Zoning Staff Report

Case Number: ZC-24-148

Zoning Map Amendment & Site Plan

SITE PLAN
McCURDY CONDOMINIUMS
2500 McCURDY STREET
FORT WORTH, TEXAS
TARRANT COUNTY

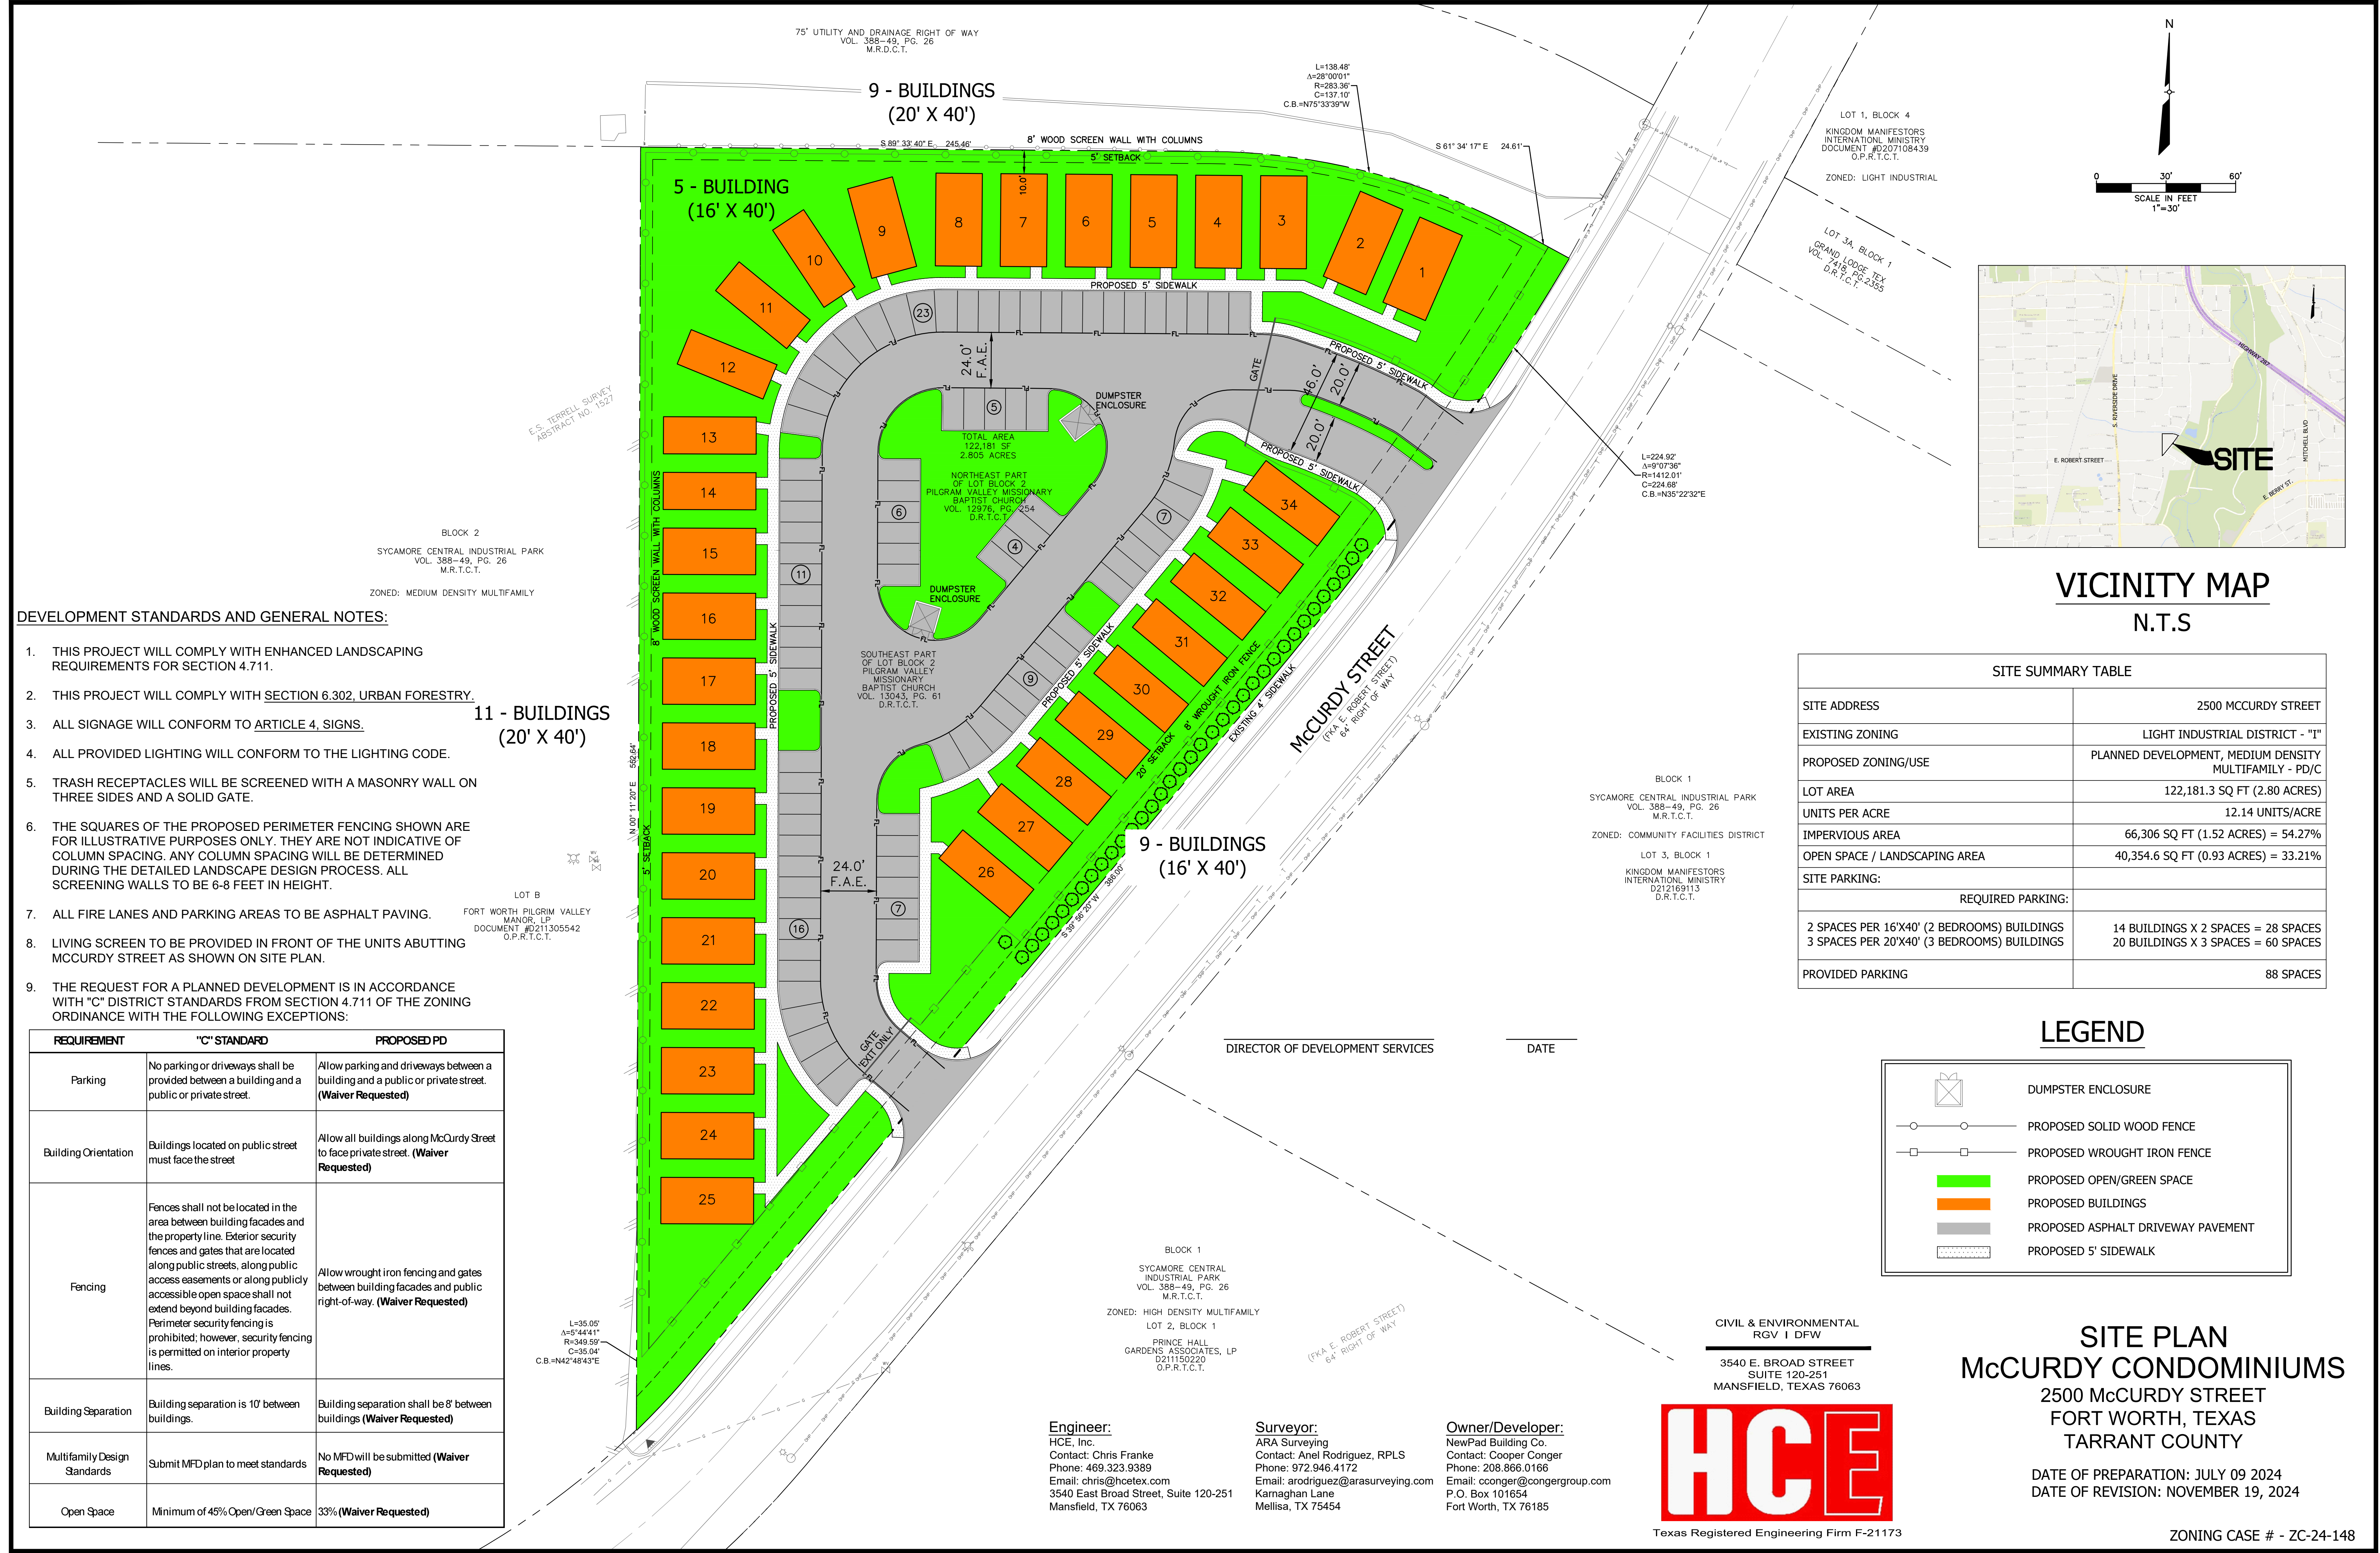
- Add zoning case reference "ZC-24-148".
- Retitle as "Site Plan" rather than "Site Concept Plan".
- On the vicinity Map, turn off aerial background and zoom out further to show major streets for reference.

- Strike "Medium Density is a maximum of 24 dwellings per acre" below Site Summary Table (redundant).
- On Site Summary Table, proposed zoning/use should be "Planned Development, Medium Density Multifamily - PD/C".

- Recalculate open space percentage on Site Summary Table to reflect the following definition of open space.
- Add Open Space waiver to table, as the open space will likely fall below the minimum 45% upon recalculation.

- Confirm you have discussed the development with Urban Forestry and can meet their standards without a waiver.
- FYI any Urban Forestry waivers need to be included on the front end.

- More clearly delineate fencing location on the Site Plan.
- Differentiate fencing types on legend (wood vs. wrought iron).
- Clarify note 8 - is the 'living screen' a part of the required landscaping or in addition to the required landscaping?

All zoning comments below cleared as of 11/25/2024
